H/22/93507 21 Roselands Close, SO50 8GN
Ecology Comments 4.10.22

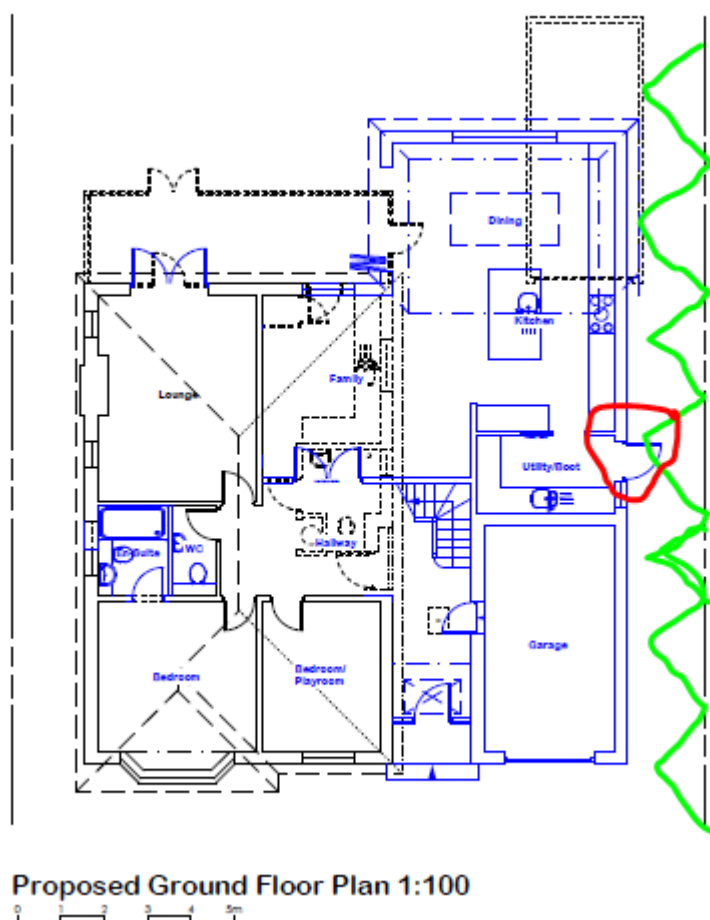
The only additional observation I have is that it appears the door from the utility room (circled red below) will open out into an existing hedge (green zig zagged line). The application form states that there will be no loss or pruning of hedgerow required but I cannot see how access through this door can function practically without works to the hedge. Please can you get clarity on this matter?
